MIL-I-48331A(AR)
AMENDMENT 1
7 January 1982

MILITARY SPECIFICATION

INTEGRATED CIRCUIT, DIGITAL, CMOS, TIME BASE AND SPECIAL PURPOSE FUNCTION GENERATOR, MONOLITHIC, SILICON

This Amendment forms a part of Military Specification MIL-I-48331A(AR), dated 15 November 1979, and is approved for use by the U.S. Army Armament Research and Development Command, and is available for use by all Departments and Agencies of the Department of Defense.

FIGURE 13

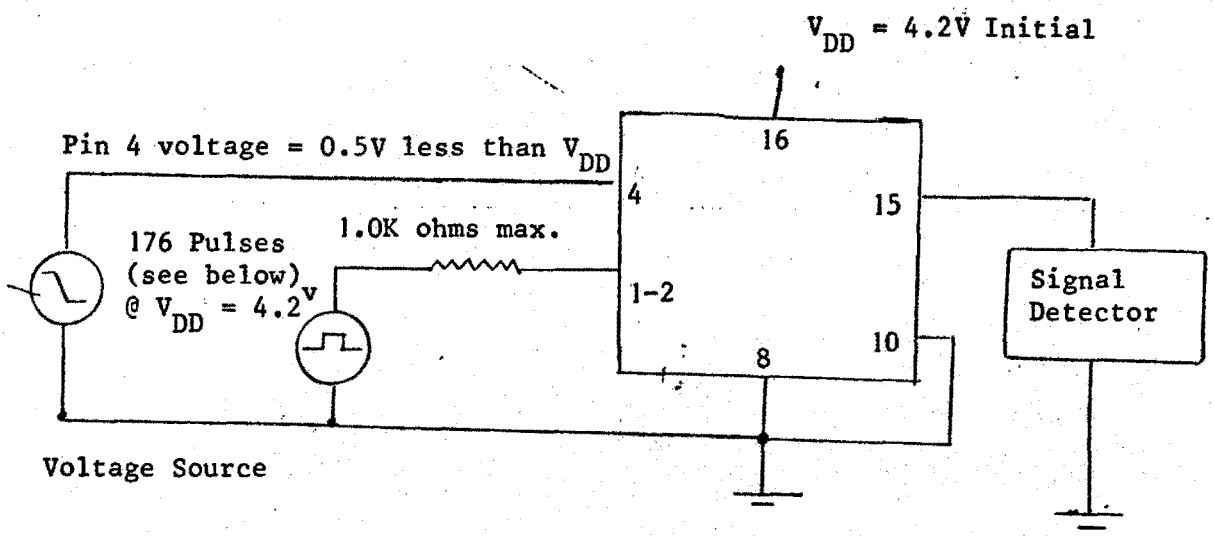
Delete Figure 13 in its entirety and add new Figure 13.

LVD FUNCTION VOLTAGE TERMINAL 15
